Aft Bracket Item Name:

DART AEROSPACE LTD	Work Order:	58476
Description: FWD BRACKET	Part Number:	D4039-3
Inspection Dwg: N 439 Rev: A		Page 1 of 1

BRACKET

Subject: D4039 Rev. PB1

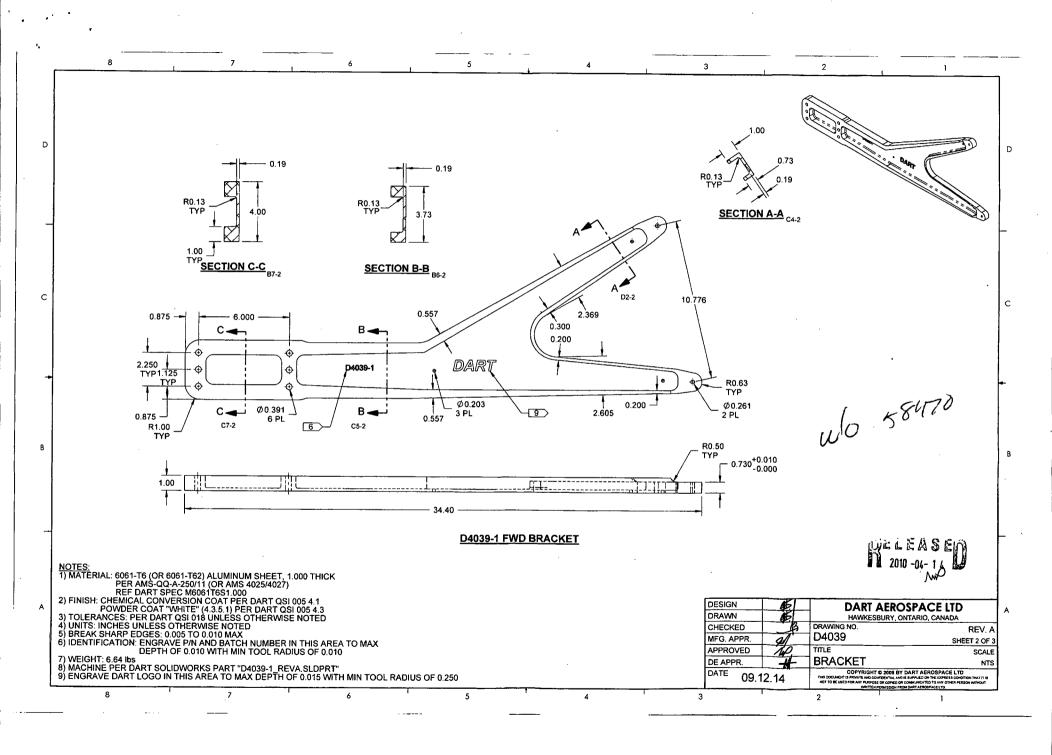
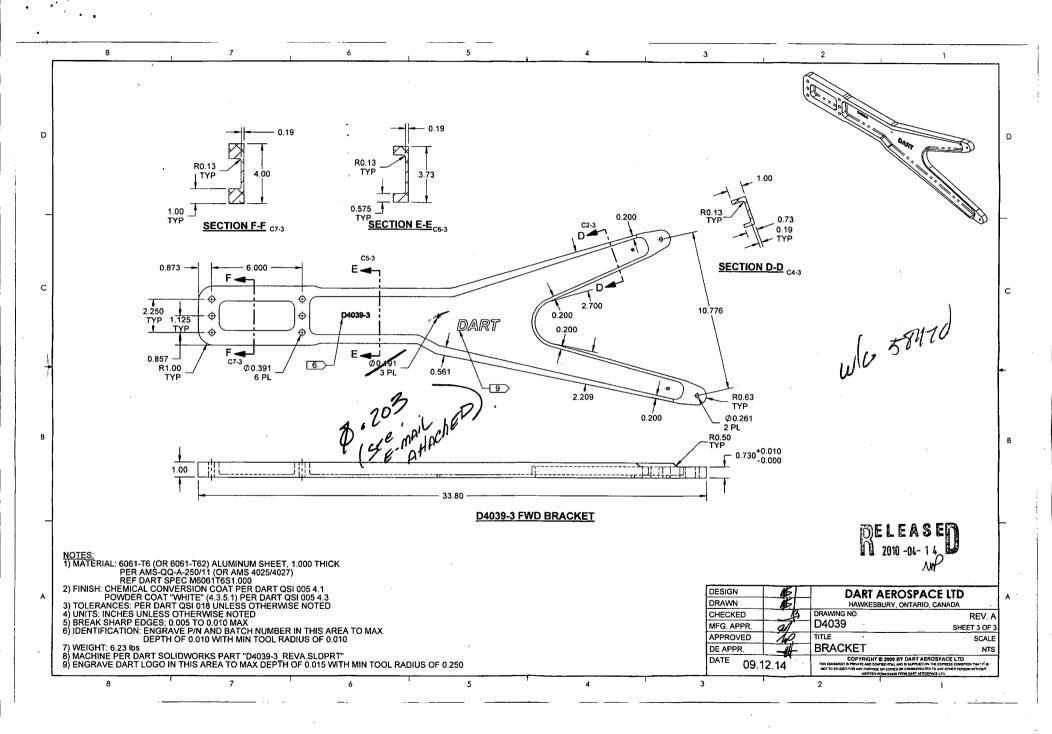
I think that the hole that I dimensioned at 0.191 was the only hole in the model that was that size. Weird since the model is based on the "other" Y brackets.

Looks good,I don't know what happened, the original parts made in December were both drilled at .203"?????

Talked with JL this morning and he raised an inconsistency between the D4039-1 and the -3 regarding the hole

Thought about Section A-A and D-D and the 0.73 dimension that is shown there vs the 0.730 +0.010/-0.000 dimension shown in zone B3. The B3 dimension is for the lug at the end while the section view dimension is just for that shorter leg of the beam. I think the way we have it dimensioned is correct. We want to maintain a tight tolerance on the lug but the shorter leg portion is not so critical. Let me know if that explanation doesn't make sense.

sizes. This discrepancy has been corrected. Since you were the original reviewers, I am forwarding the prelim drawing to you. Thank you for your time in going over the attached drawing. Let me know if there are any other details that need to be changed or adjusted.

If everybody is good with it (let me know) I'll revise the MDL and issue an ECN. David will approve shortly after that and you'll have an updated drawing.
